1190-8980635-00-D

**ENGINEERING CHANGE REQUEST (ECR)**

CUSTOMER DRAWING NO. D972715

DRAWING TITLE HAM stack Pins.

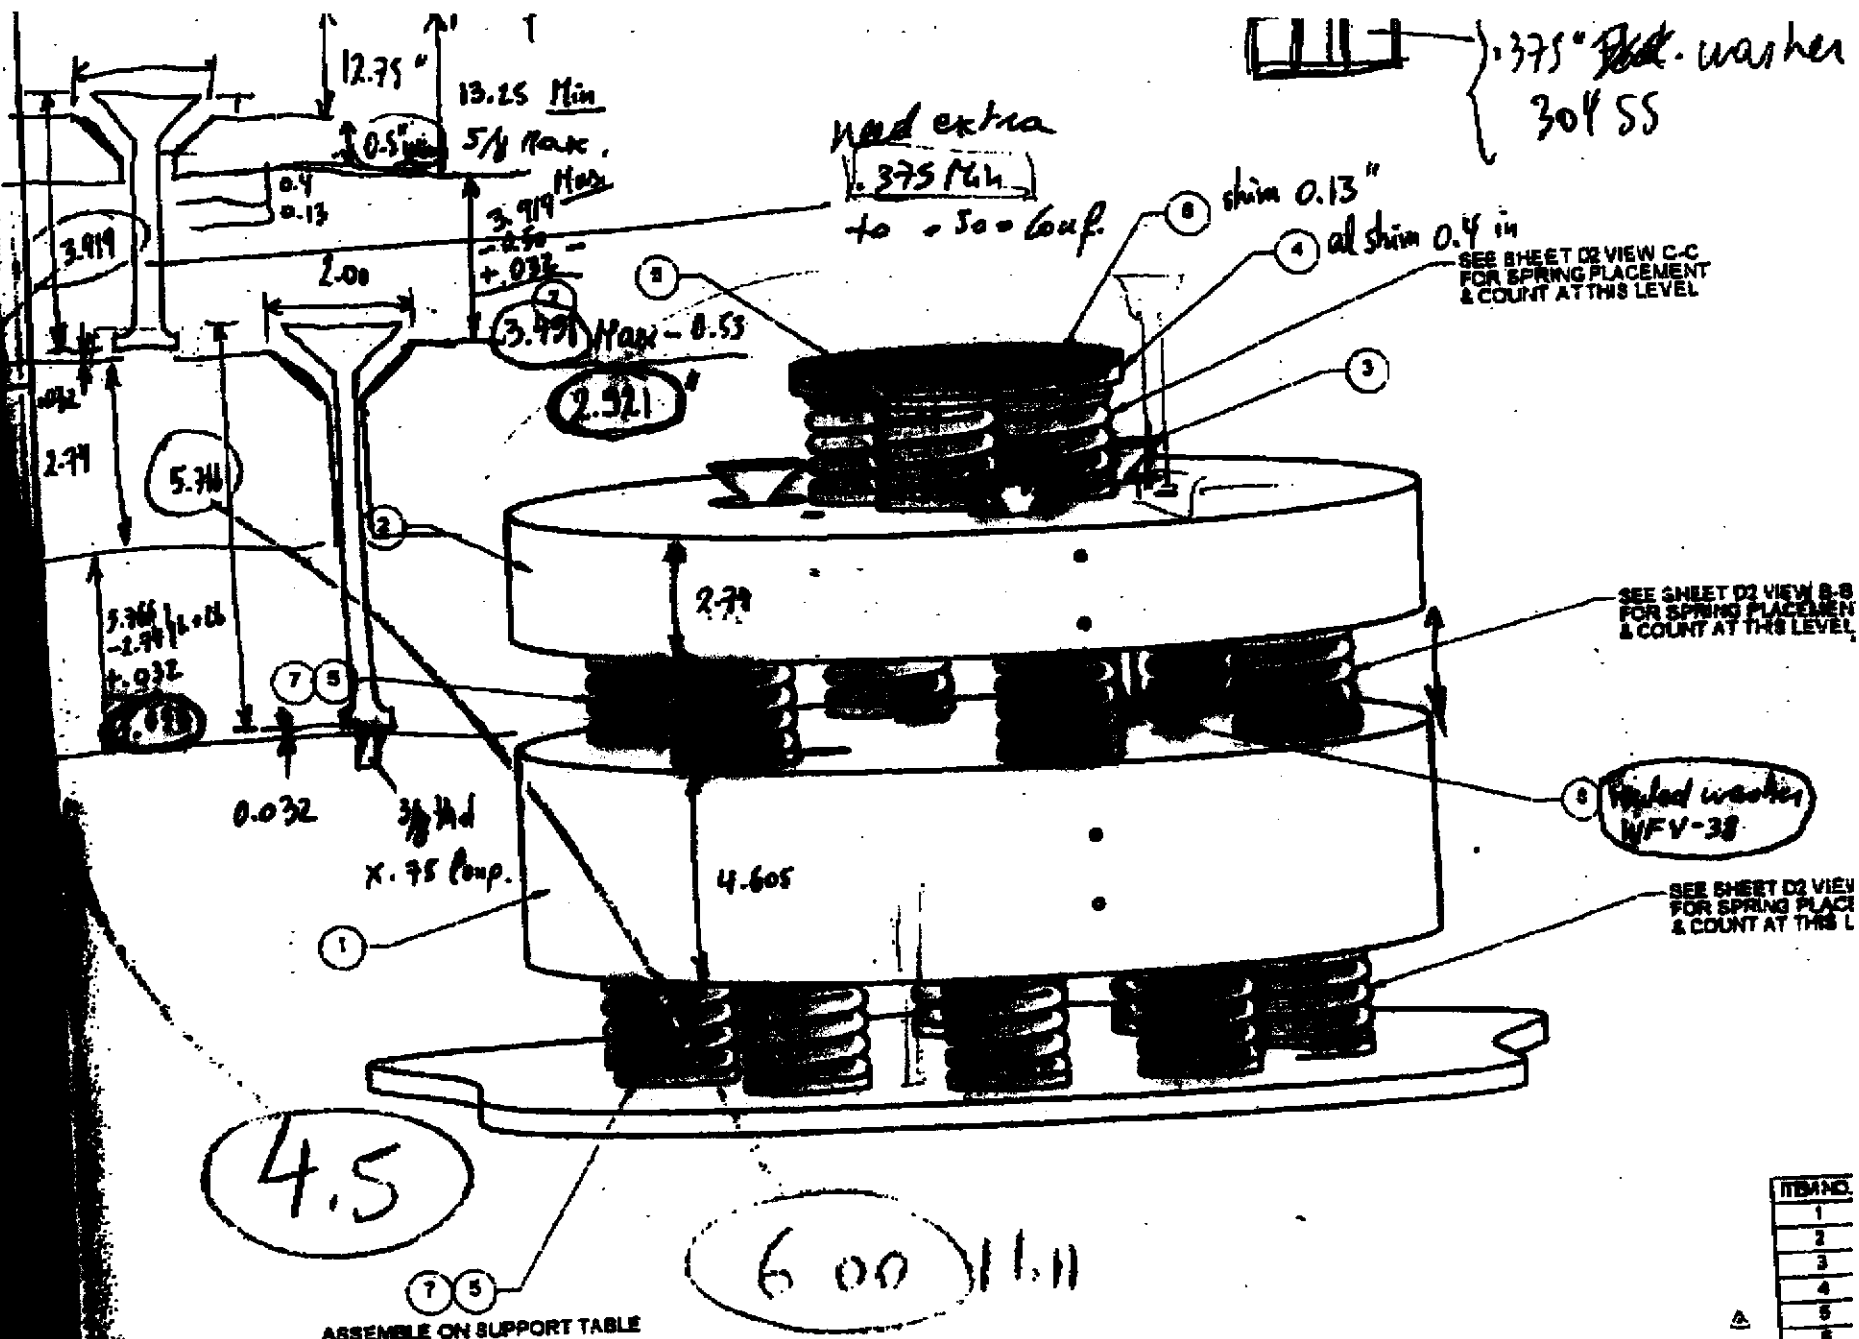
• conical head pins: change lengths  
 D972715-1 : from 3.919 to 4.50  
 D972715-3 : from 5.766 to 6.00

• insufficient clearance to insert coil springs

⚠ to be changed for production release only.
